KEYSTONE PIPELINE PROJECT - U.S. PHASE IV (STEELE CITY SEGMENT)

KEYSTONE PIPELINE PROJECT - U.S. PHASE IV (STEELE CITY SEGMENT) ROUTE VARIATION AUTHORIZATION FORM			
Date: <input style="width: 100%;" type="text" value="9/14/2010"/>	Tracking Number: <input style="width: 100%;" type="text" value="0178-SD-P2-593.3-594.6-S"/>		
Description: <input style="width: 100%;" type="text" value="Reroute to avoid Cultural features."/>	MP: <input style="width: 20%;" type="text" value="593.3"/> to <input style="width: 20%;" type="text" value="594.6"/>		
Originated By: <input style="width: 100%;" type="text" value="Environmental"/>		Variation Form Attached: Yes <input checked="" type="checkbox"/> No <input type="checkbox"/>	
Universal Field - Land Doug Reichley	Variation: Approved <input checked="" type="checkbox"/> Rejected <input type="checkbox"/>		
Comments: <input style="width: 100%; height: 40px;" type="text"/>	<input style="width: 100%;" type="text" value="Doug Reichley"/> Date: <input style="width: 100%;" type="text" value="9/14/2010"/>

KEYSTONE XL PROJECT - STEELE CITY SEGMENT
PROPOSED ROUTE VARIATION 0178
TRIPP COUNTY, SD

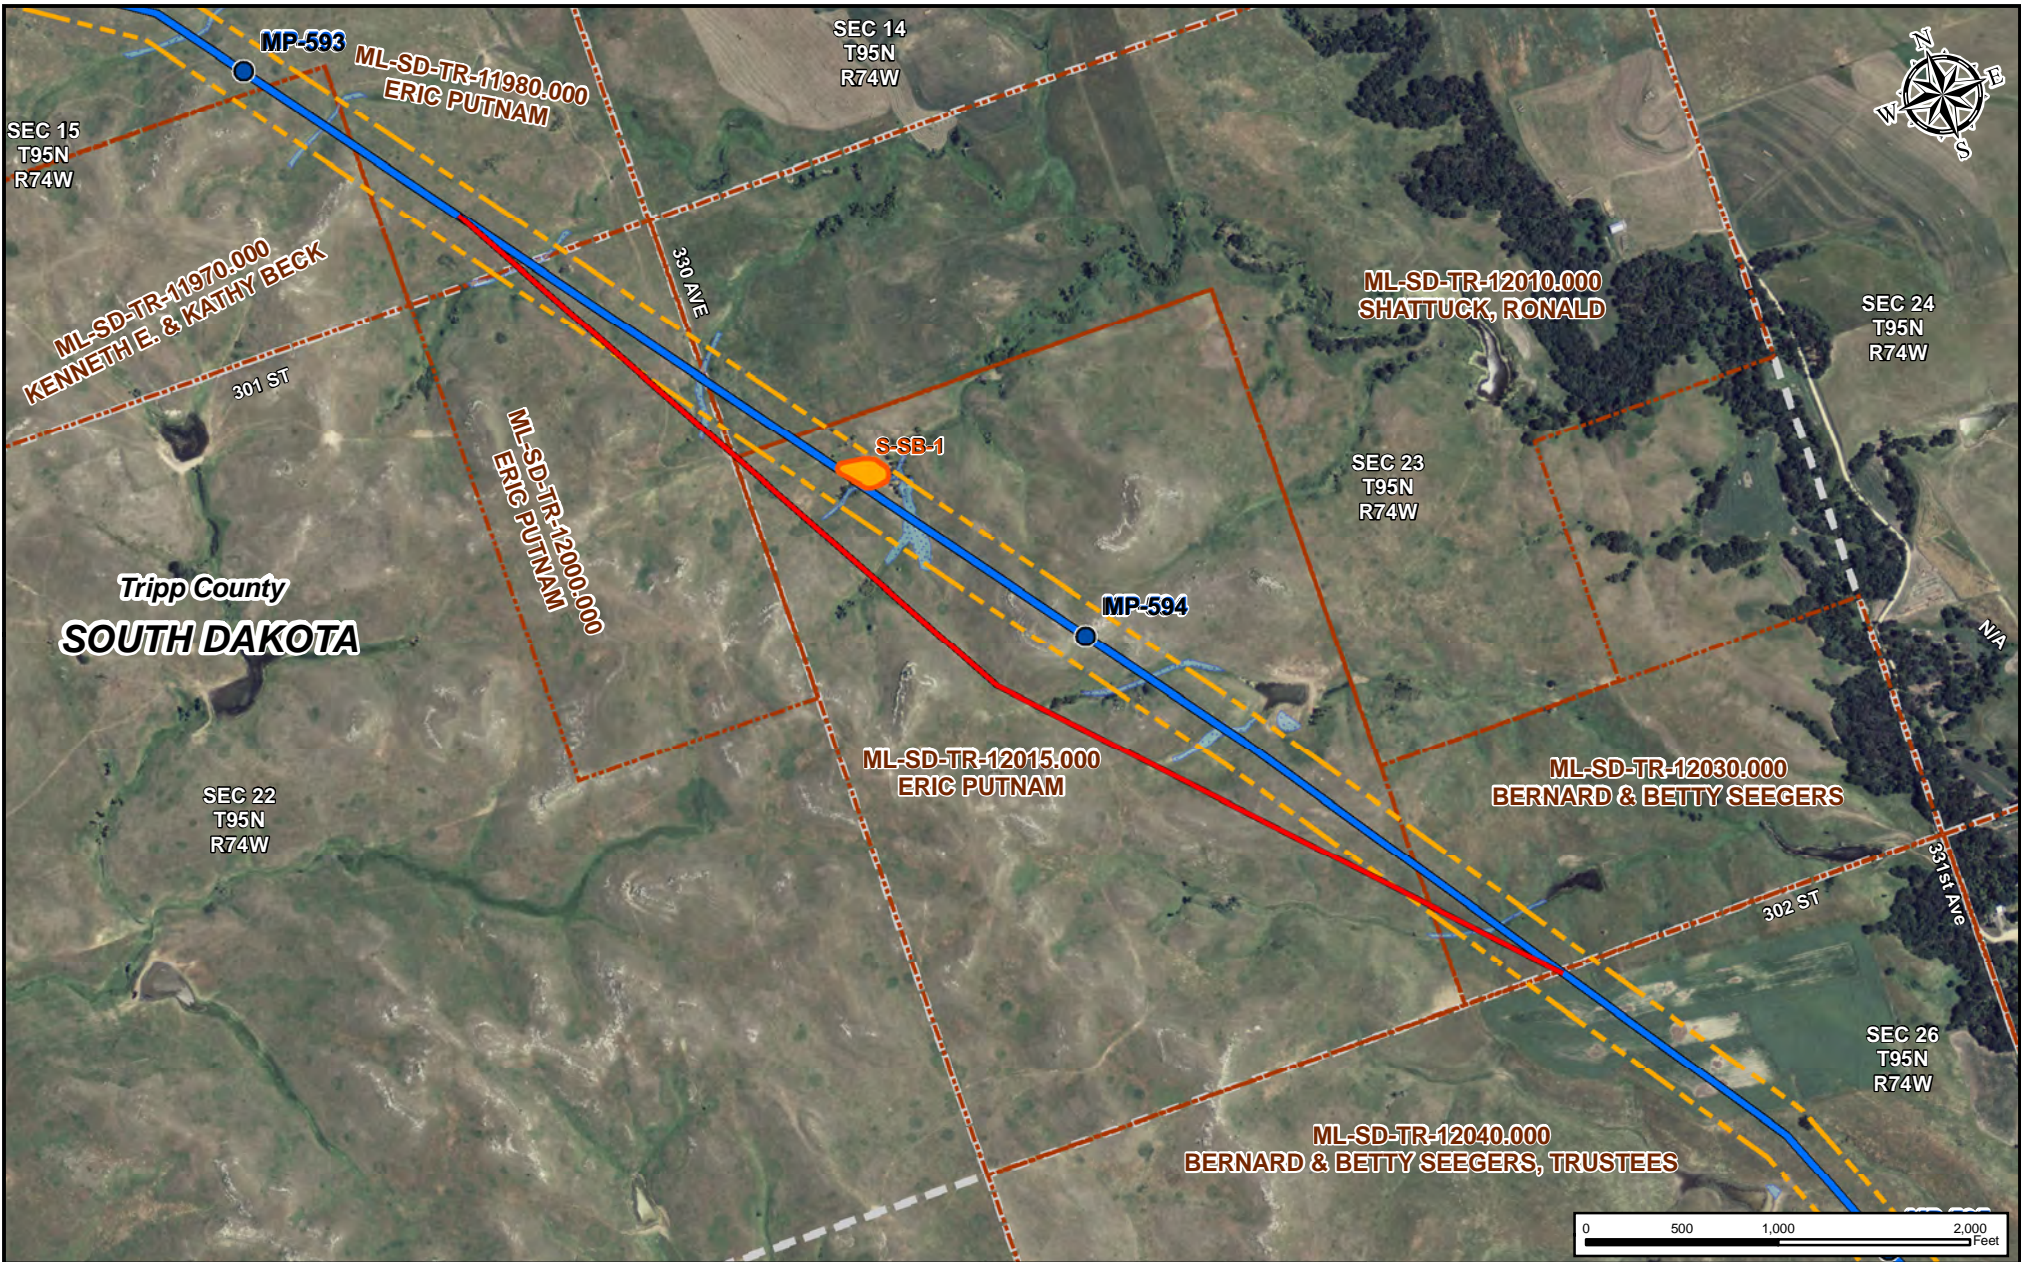
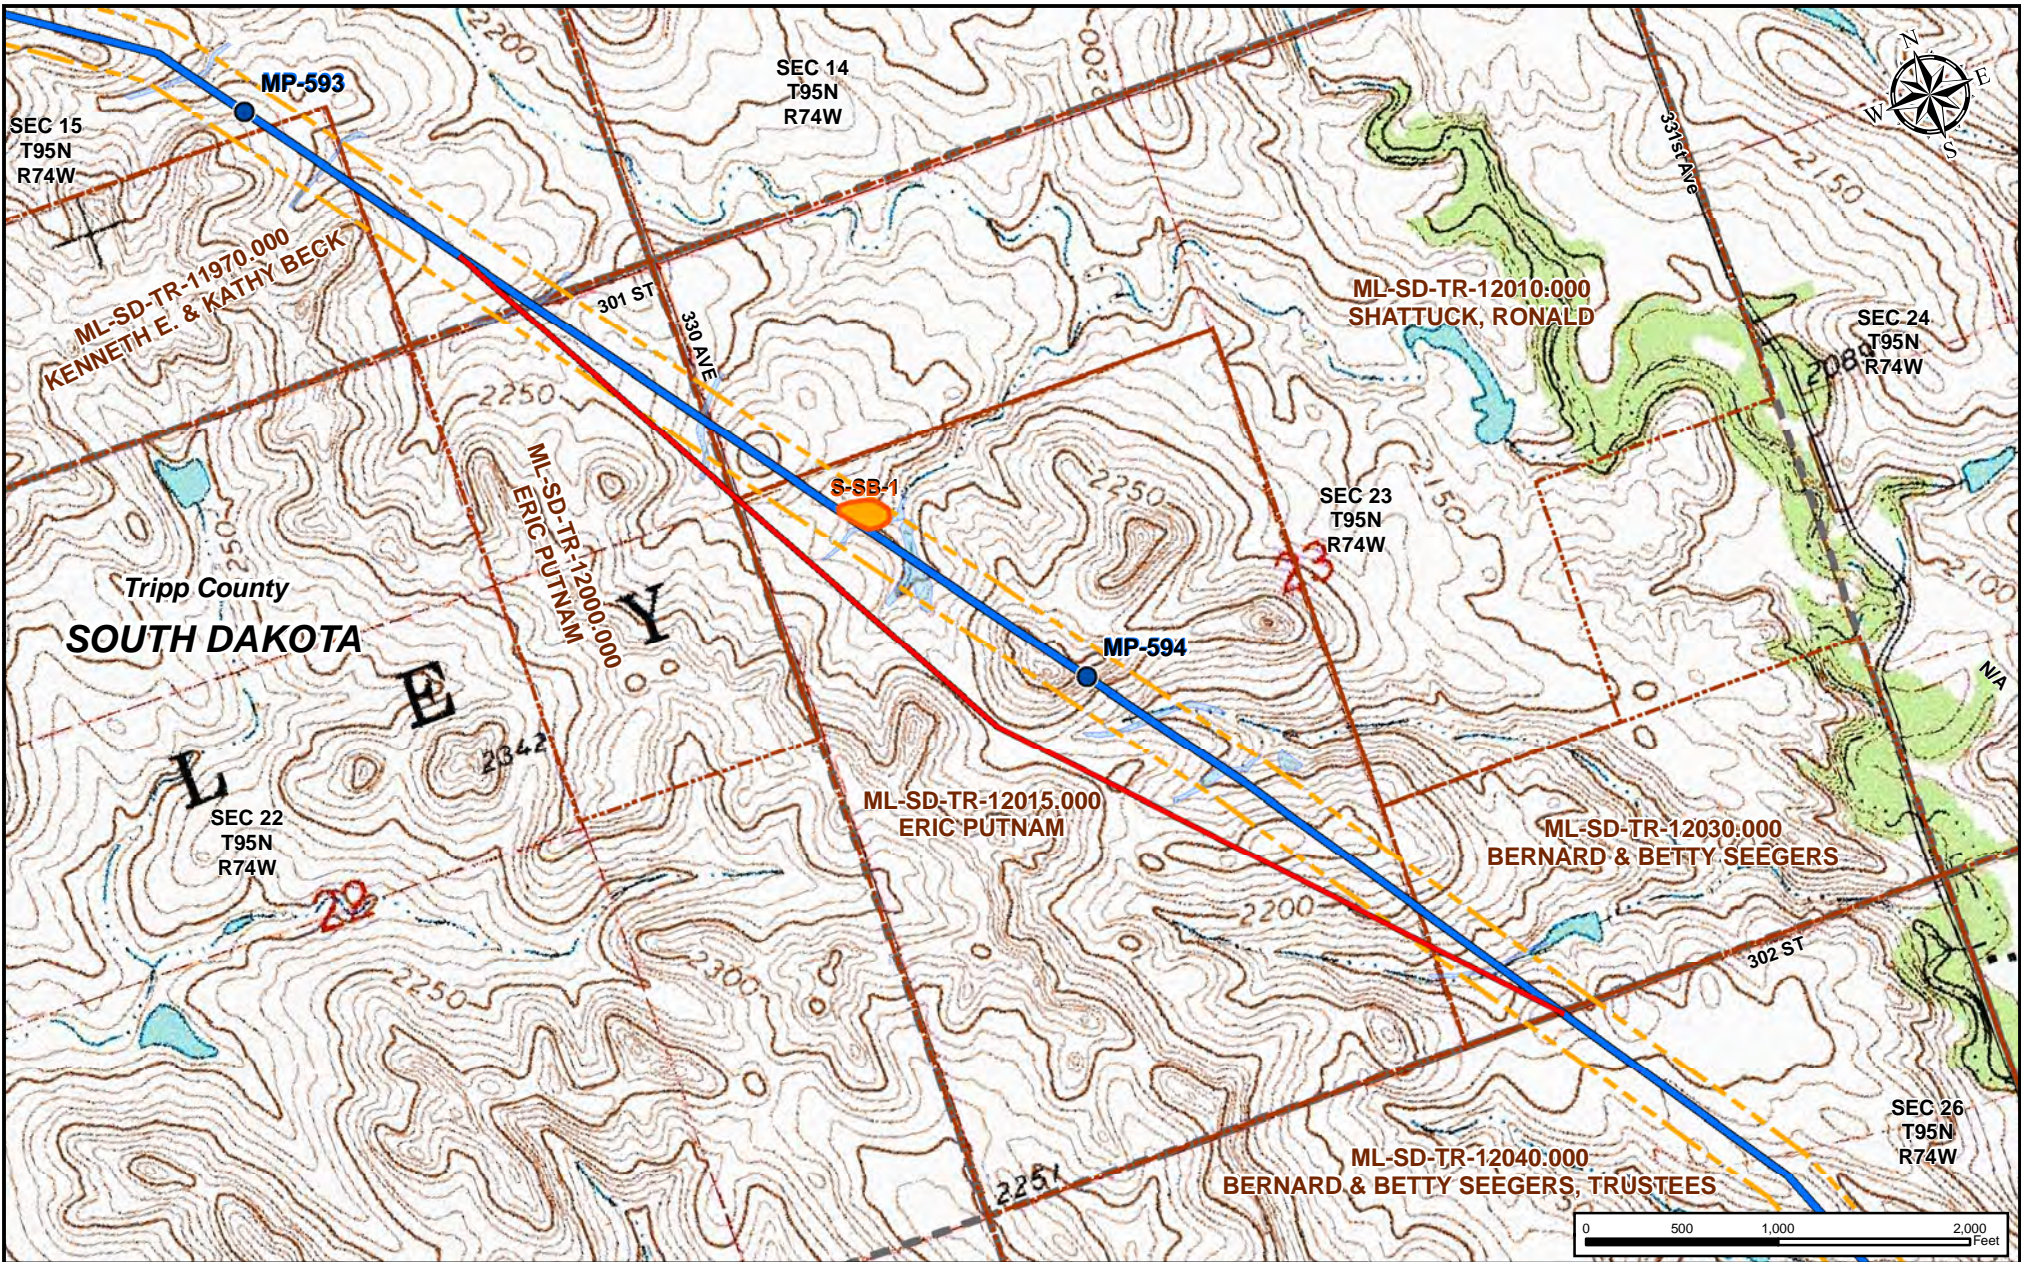
This reroute is proposed to avoid any construction impacts to a cultural feature near MP 593.7.			
	DETAIL ROUTE VARIATION (Please describe route variation in detail):			
	The proposed reroute starts at MP 593.2 and deviates slightly (~8°) towards the southeast. It continues in this direction for ~3,720 ft until it avoids the side slope of a small hill near MP 594, along its path the proposed reroute keeps away (~300 ft to avoid any impacts) from the cultural resource feature near MP 593.7. The proposed reroute then turns towards the east and continues for 3,310 ft to rejoin the current centerline at near MP 594.6.			
	ADDITIONAL IMPACTS (Please include any additional impacts which may affect cost; crossings, induction bends, etc.):			
	The proposed reroute is ~53 ft longer than the current route.			
	Is there an increase/decrease in the number of crossings? Yes <input type="text"/> No <input checked="" type="checkbox"/>
